Access Compliance Report

Public Rights-of-Way

(Curb Ramps)

Intersection ID: 29981	Main Street: OLD_CAROLINA_DR	Cross Street: WINDING_RIVER_DR	Location: S
ADA ID: 8947EACBBED7	Ramp Type: PerpDiag	Initial Pass/Fail: Fail	Overall Compliance: No
		Severity Score: 8.75

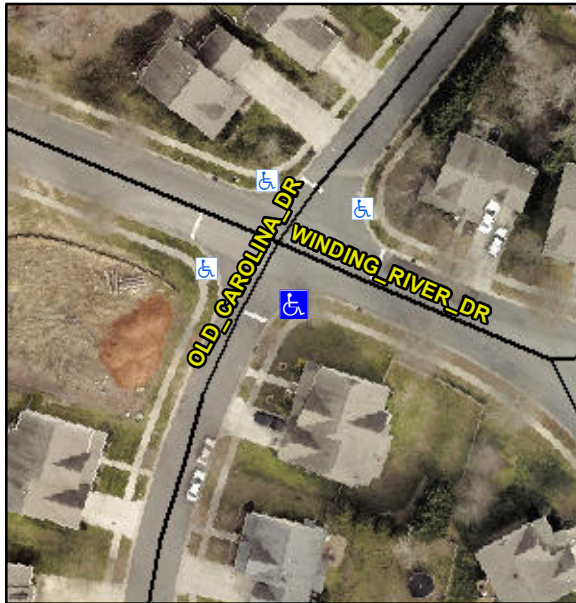
Not Found, R304.5.1

Compliance	Description	Data	Compliance	Description	Data
N/A	Ramp Length (in)	71.0	Yes	Ramp Slope (%)	5.0
No	Ramp Width (in)	47.0	Yes	Ramp XSlope (%)	0.7
N/A	Flare Type LT	N/A	N/A	Flare Type RT	N/A
N/A	Flare Slope LT (%)	N/A	N/A	Flare Slope RT (%)	N/A
N/A	Flare Traversable LT?	N/A	N/A	Flare Traversable RT?	N/A
N/A	Landing Length (in)	N/A	N/A	DWS Provided?	N/A
N/A	Landing Width (in)	N/A	N/A	DWS Contrast?	N/A
N/A	Landing Slope (%)	N/A	N/A	DWS Length (in)	N/A
N/A	Landing X Slope (%)	N/A	N/A	DWS Full Width?	N/A
N/A	Landing Curb? (Y/N)	N/A	N/A	DWS Offset (in)	N/A
N/A	Shared Landing?	N/A			
N/A	Gutter Ponding?	N/A	N/A	Gutter Slope (%)	N/A
N/A	Gutter Lip Ht (in)	N/A	N/A	Gutter X Slope (%)	N/A
N/A	Painted X Walk1?	No	N/A	Painted X Walk2?	No
	X Walk 1 Direction	To NE		X Walk 2 Direction	To NW
N/A	X Walk 1 Width (in)	N/A	N/A	X Walk 2 Width (in)	N/A
	X Walk 1 Slope (%)	2.3		X Walk 2 Slope (%)	5.2
	X Walk 1 X Slope (%)	5.2		X Walk 2 X Slope (%)	3.4

Remove & Replace Curb Ramp With Two New Directional Ramps or Equivalent.
